NEDO-10958-A
Class I
January 1977

**GENERAL ELECTRIC BWR THERMAL ANALYSIS BASIS (GETAB):
DATA, CORRELATION AND DESIGN APPLICATION**

The Regulatory staff has completed its review of the General Electric Company proprietary topical report NEDE-10958, "General Electric BWR Thermal Analysis Basis (GETAB): Data, Correlation and Design Application". Enclosure 1 is the Regulatory staff's evaluation of this report.

Figure 4 MEASURED VS. PREDICTED CRITICAL HEAT FLUX FOR ATLAS DATA WITH UNIFORM AXIAL AND UNIFORM

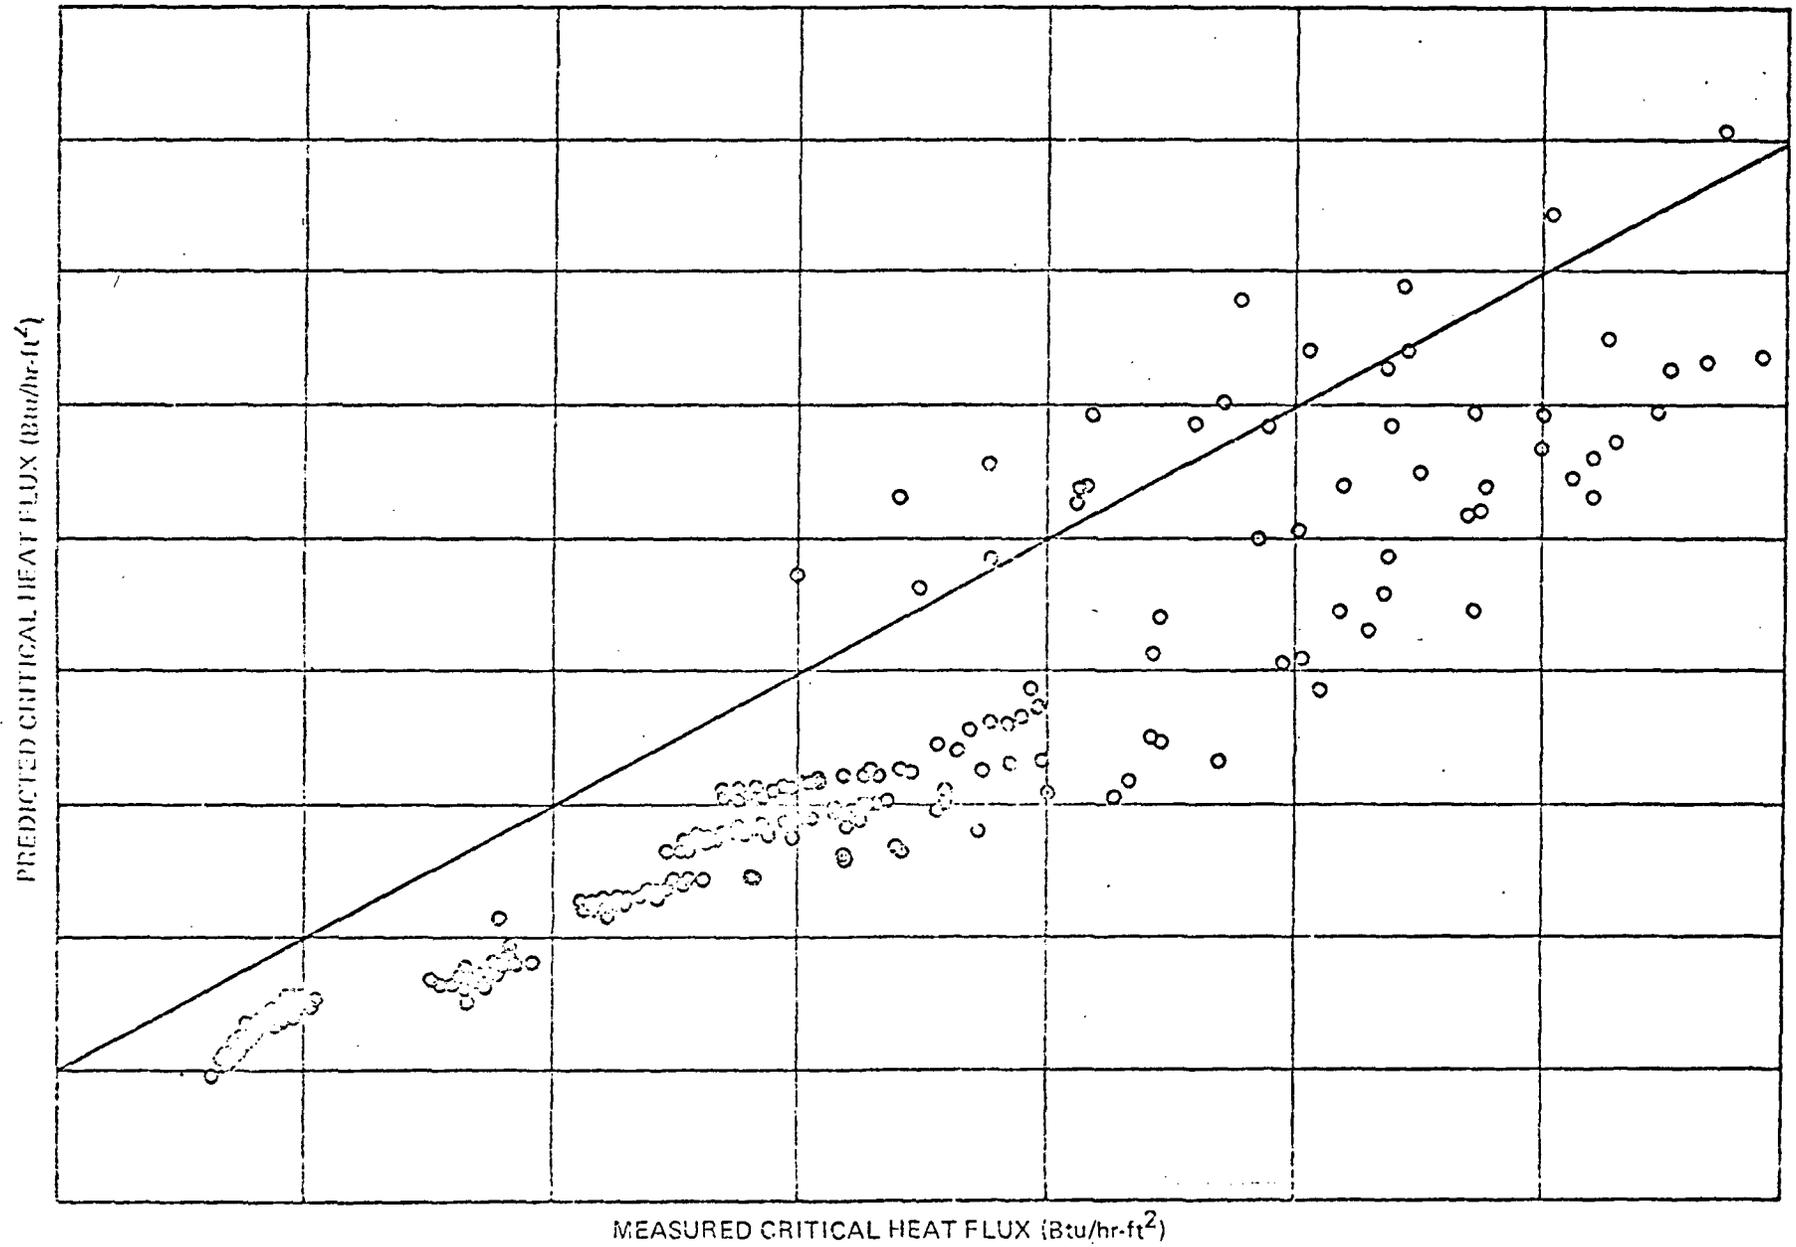
A comparison between measured and predicted critical heat flux (Hench-Levy) for uniform axial and radial heat flux distribution, is shown in Figure 4.⁽¹⁷⁾ It can be seen that almost all of the measured heat fluxes are greater than the predictions thus showing that, for these conditions, the Hench-Levy correlation is conservative. This result is not too surprising as the experimental basis for establishing the Hench-Levy correlation was primarily comprised of uniform axial and radial heat flux rod bundle data. However, as shown in the following two figures, the greater the departure from uniform axial and radial heat flux distribution, the greater becomes the disparity between the Hench-Levy correlation and measured critical heat fluxes, with Hench-Levy being the higher.

Figure 5 MEASURED VS. PREDICTED CRITICAL HEAT FLUX FOR ATLAS DATA WITH UNIFORM AXIAL POWER PROFILE

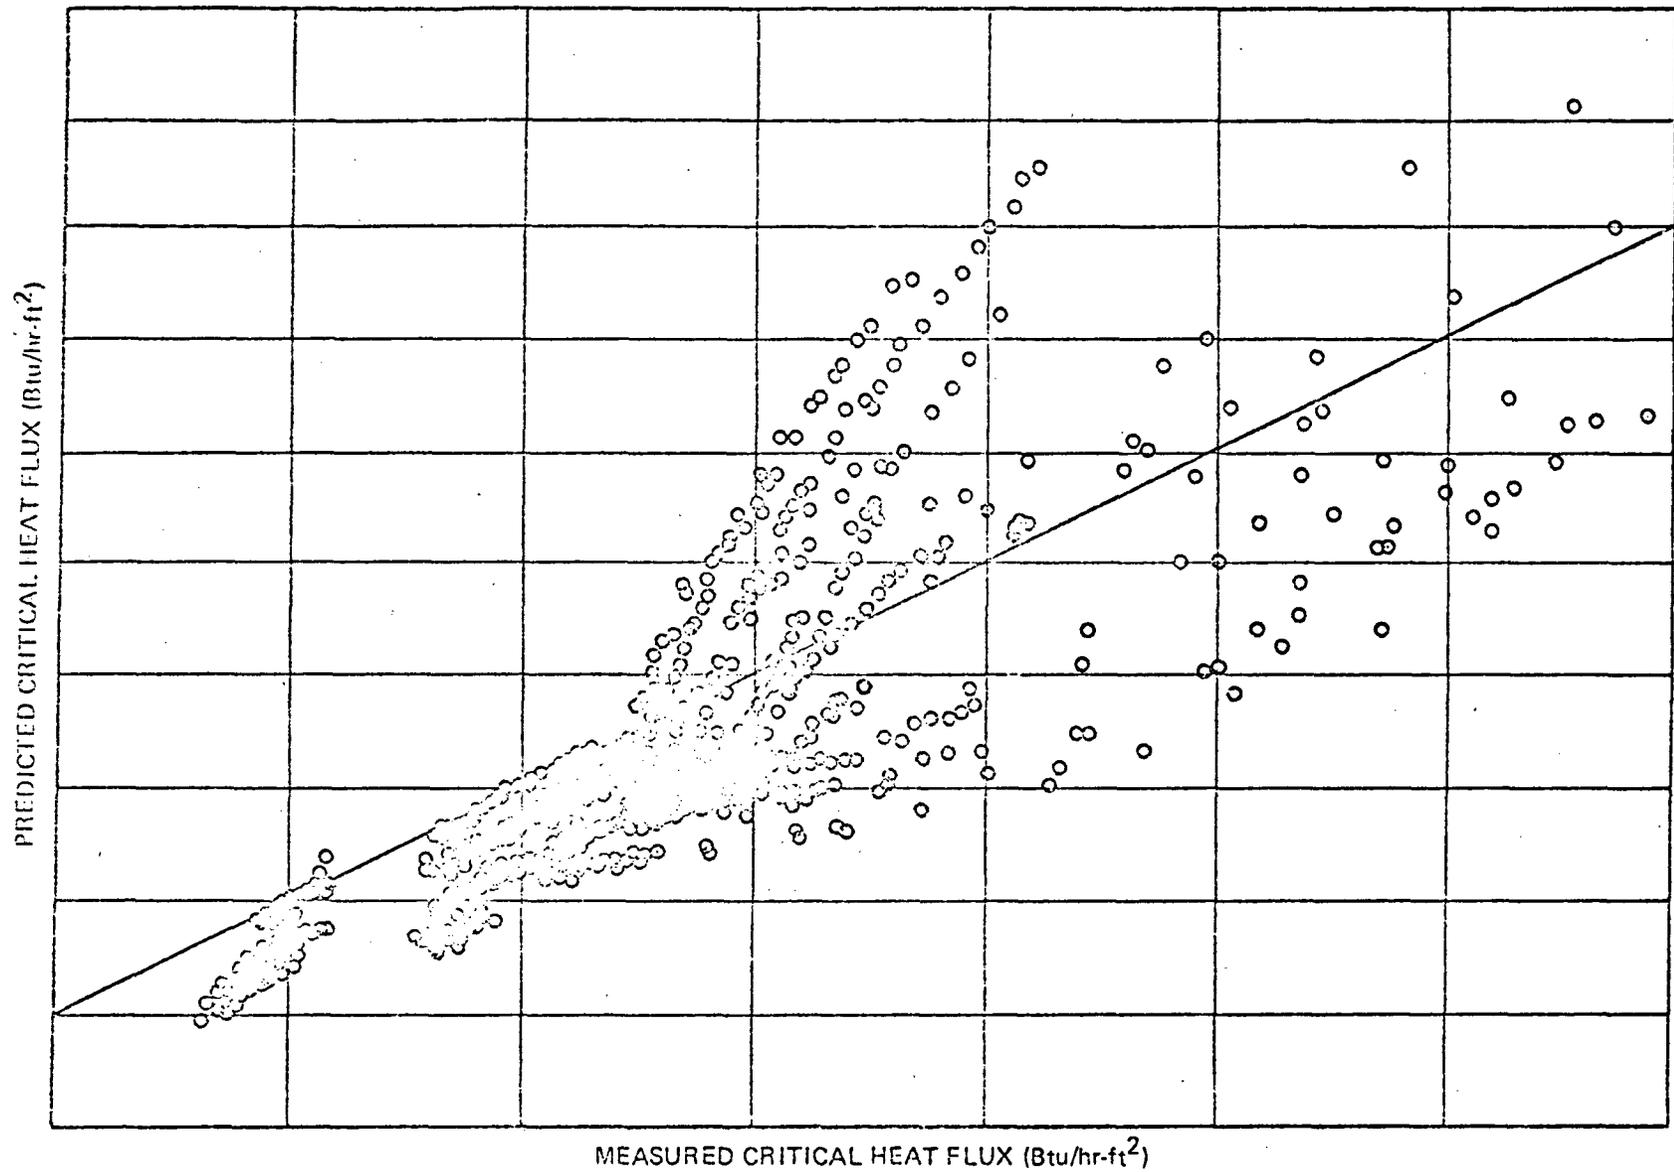
Figure 5,⁽¹⁷⁾ which compares critical heat flux for uniform axial heat flux and non-uniform radial peaking to predictions, shows that about one-half of the data points are less than the Hench-Levy prediction. When corner peaking is combined with non-uniform axial heat flux distributions (cosine, inlet peak, outlet peak, double hump), the comparison in Figure 6⁽¹⁷⁾ results. Here it is seen that, for the vast majority of data points, the Hench-Levy predictions substantially exceed the measured critical heat fluxes. Thus, it can be concluded that, for rod bundle heat flux distributions and heated lengths which correspond to those found in a GE BWR (non-uniform axial heat flux with corner peaking, 12 ft. heated length) the Hench-Levy correlation does not provide a lower limit line.

Figure 8 COMPARISON OF HENCH-LEVY AND GEXL WITH 49 ROD ATLAS DATA
 (1.23 CORNER PEAKING, COSINE)

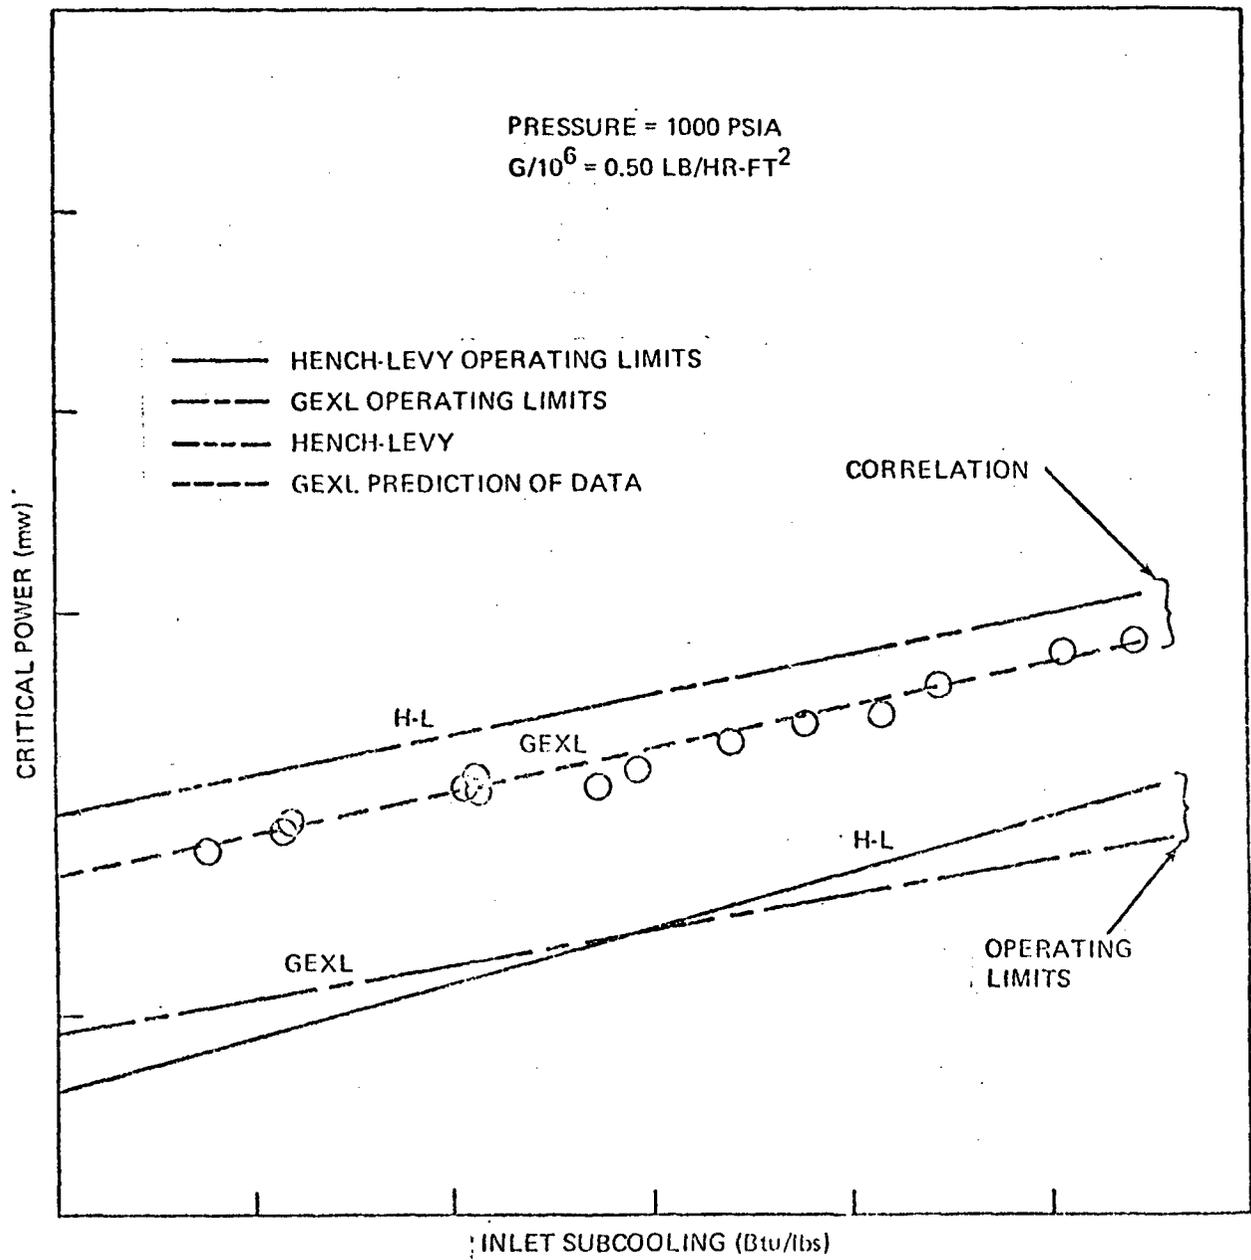
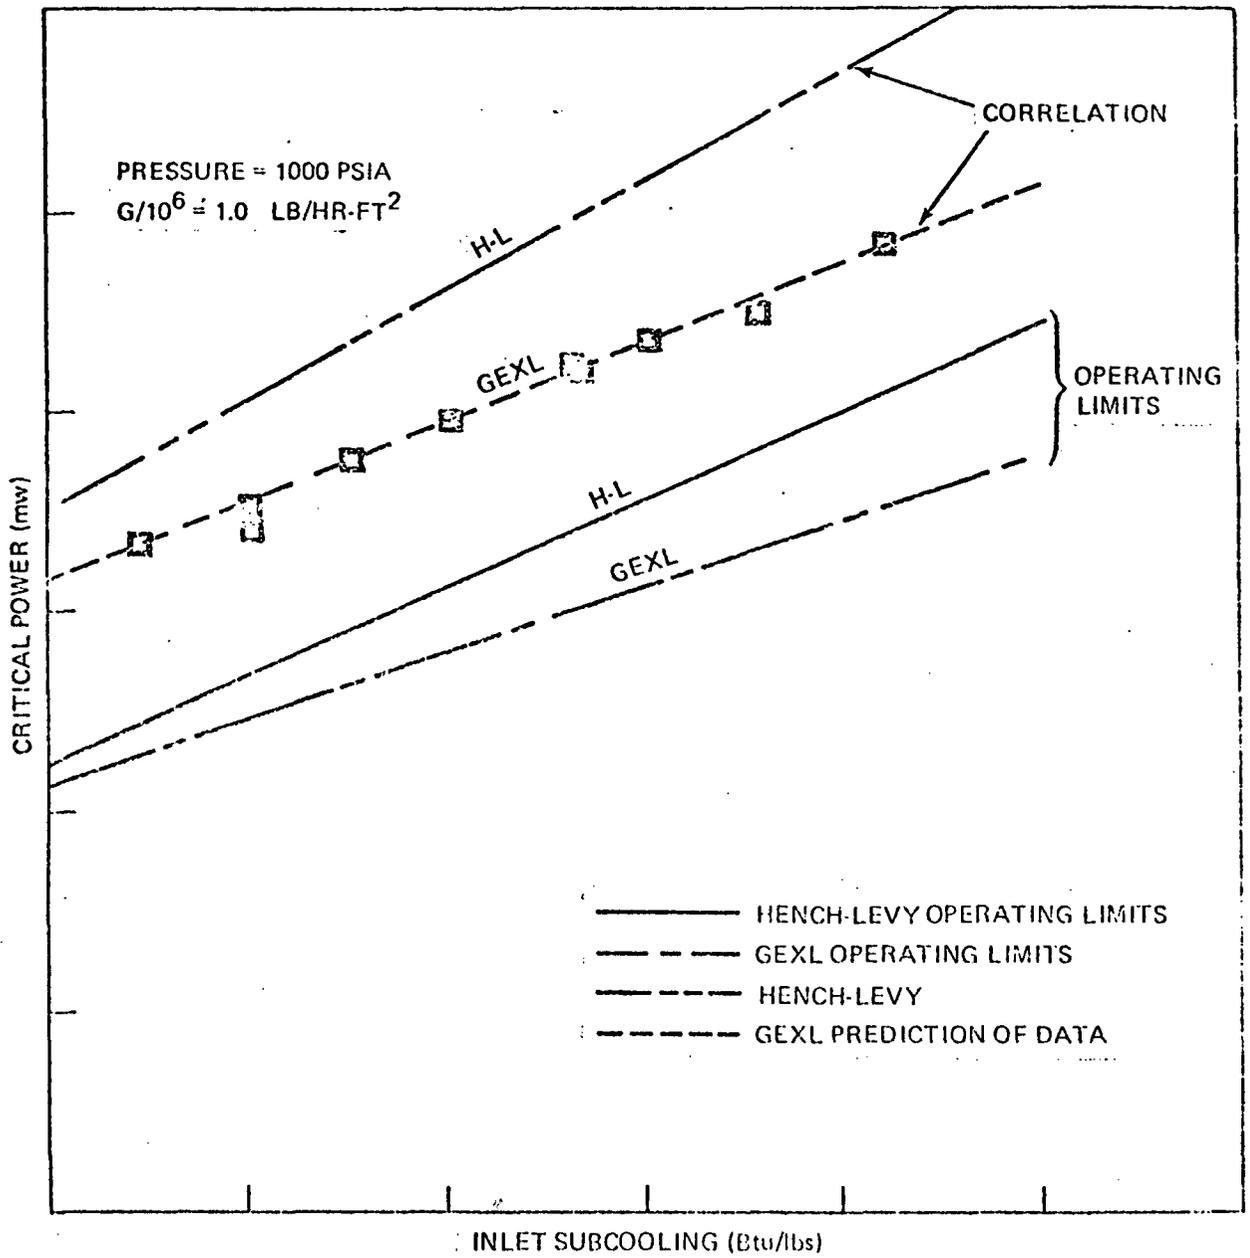
Figures 8 and 9 show critical power, for a 7 x 7 rod bundle, as a function of inlet subcooling, for mass velocities of $.5 \times 10^6$ and 1×10^6 lb/hr-sq.-ft., respectively. The two upper curves in Figure 8 represent the Hensch-Levy correlation and GEXL, respectively, along with experimental data. It is seen that the Hensch-Levy correlation predicts about 5 percent greater power than GEXL or the data. The two lower curves represent the operating curves for each of the correlations; Hensch-Levy is based on critical heat flux divided by 1.9 whereas GEXL is, in a typical case, based on critical bundle power divided by 1.2.* Note that, with respect to the operating curves, GEXL permits higher power than Hensch-Levy at low inlet subcoolings while the converse holds true at high inlet subcoolings. At a mass velocity of 1×10^6 lb/hr sq. ft., as shown in Figure 9, both the Hensch-Levy correlation and its operating curve are always higher than the respective GEXL curves.

*As discussed in Section 4, use of the arithmetic mean, rather than the geometric mean, in the statistical analysis, will increase the required CPR from 1.20 to 1.24. This would correspondingly lower the GEXL operating curves on both Figure 8 and 9.

Figure 10 RESIDUAL VS. AXIAL POWER SHAPE FOR GEXL CORRELATION OF ATLAS DATA

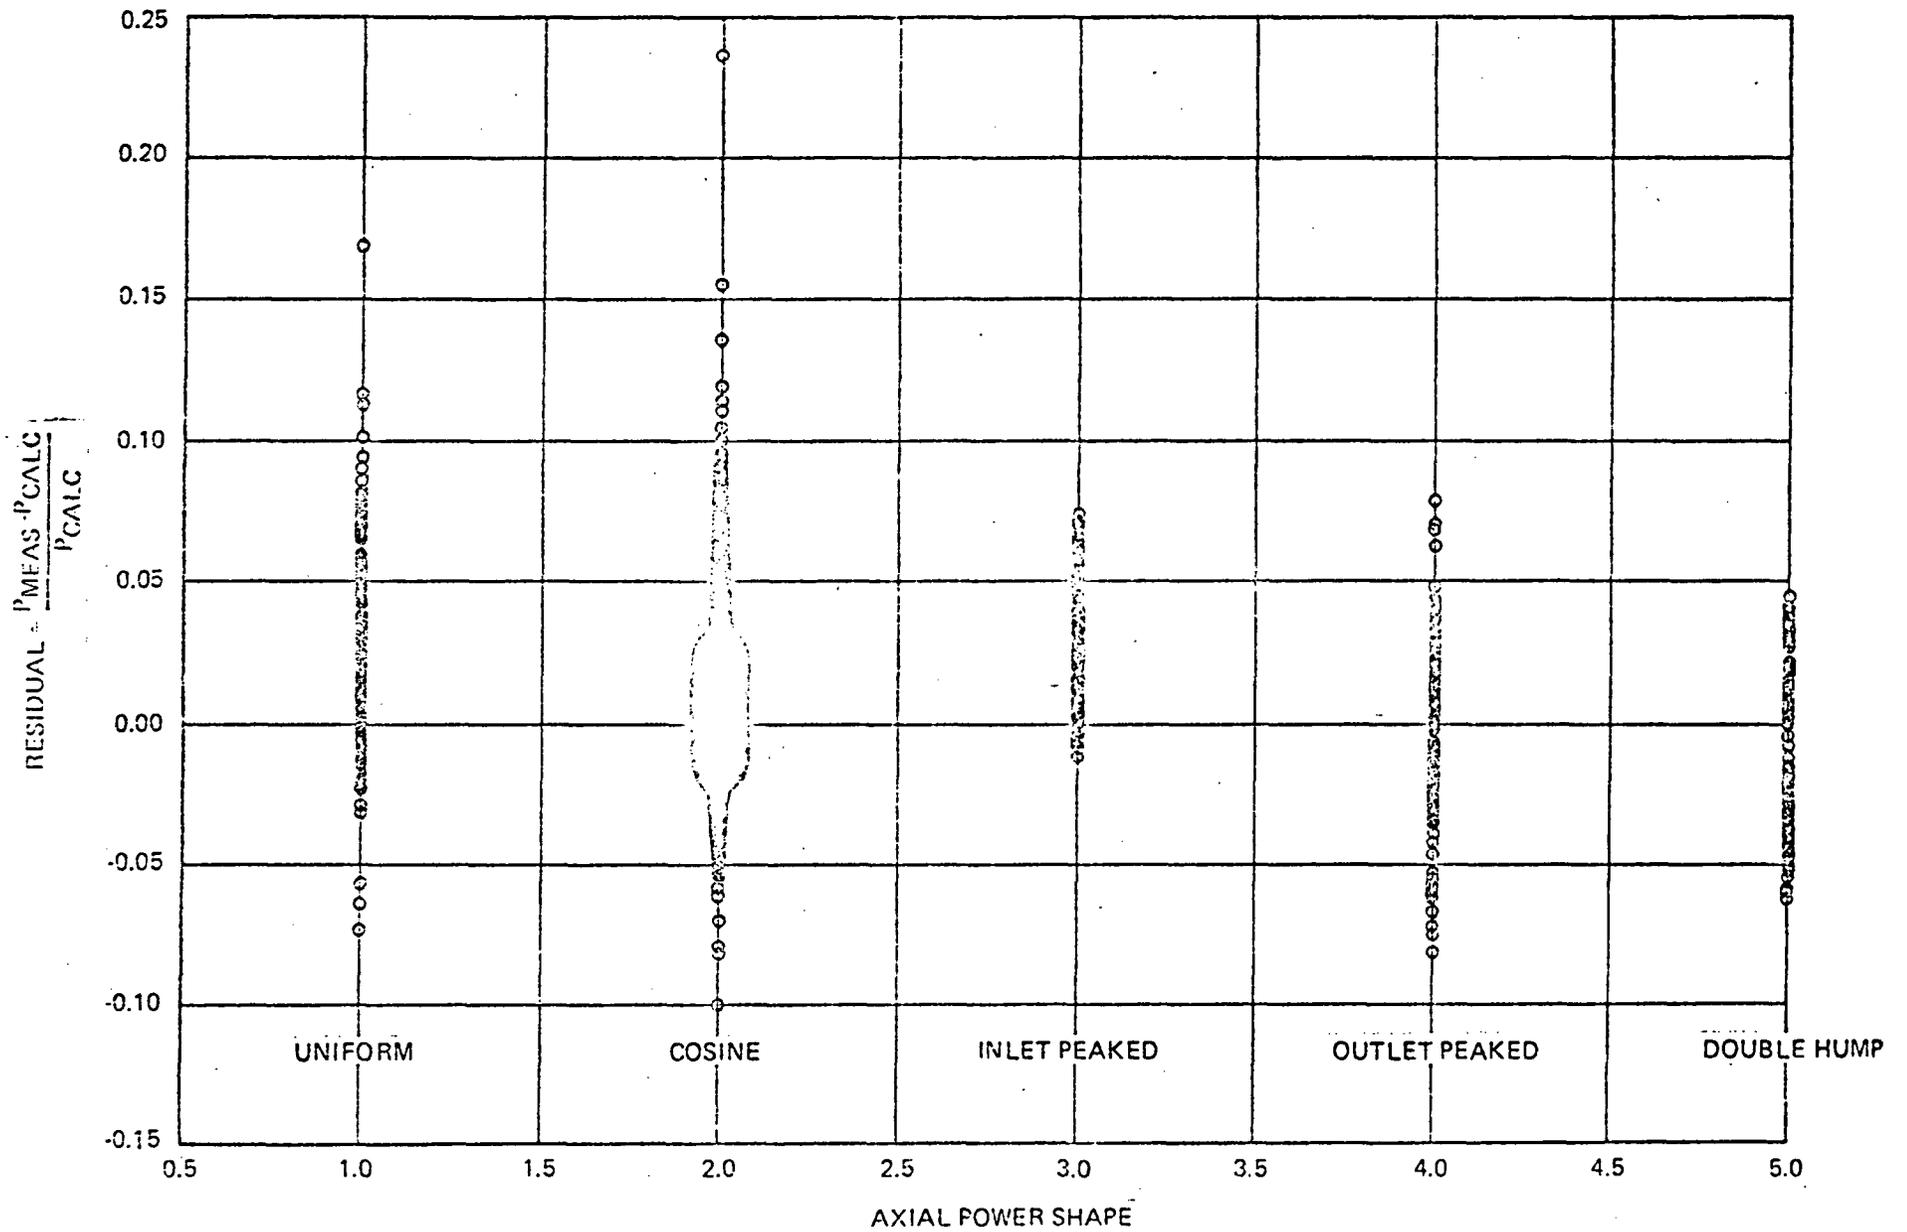
The variation of the ratio of the difference between the measured and calculated power to calculated power with axial flux shape is shown in Figure 10. When compared to the uniform and cosine power shapes which formed the basis for the 7 x 7 and 8 x 8 GEXL correlations, the inlet peak shape is seen to be slightly conservative while the outlet peak and double hump shapes are slightly non-conservative. The same relative positions among the various axial power shapes is shown, in terms of predicted to measured power, on p. 5-5 of Reference 3. However, it should be noted that these comparisons are applicable only to the 7 x 7 lattice as data with inlet peak, outlet peak, and double hump axial shapes have not, as yet, been obtained with the 8 x 8 lattice.
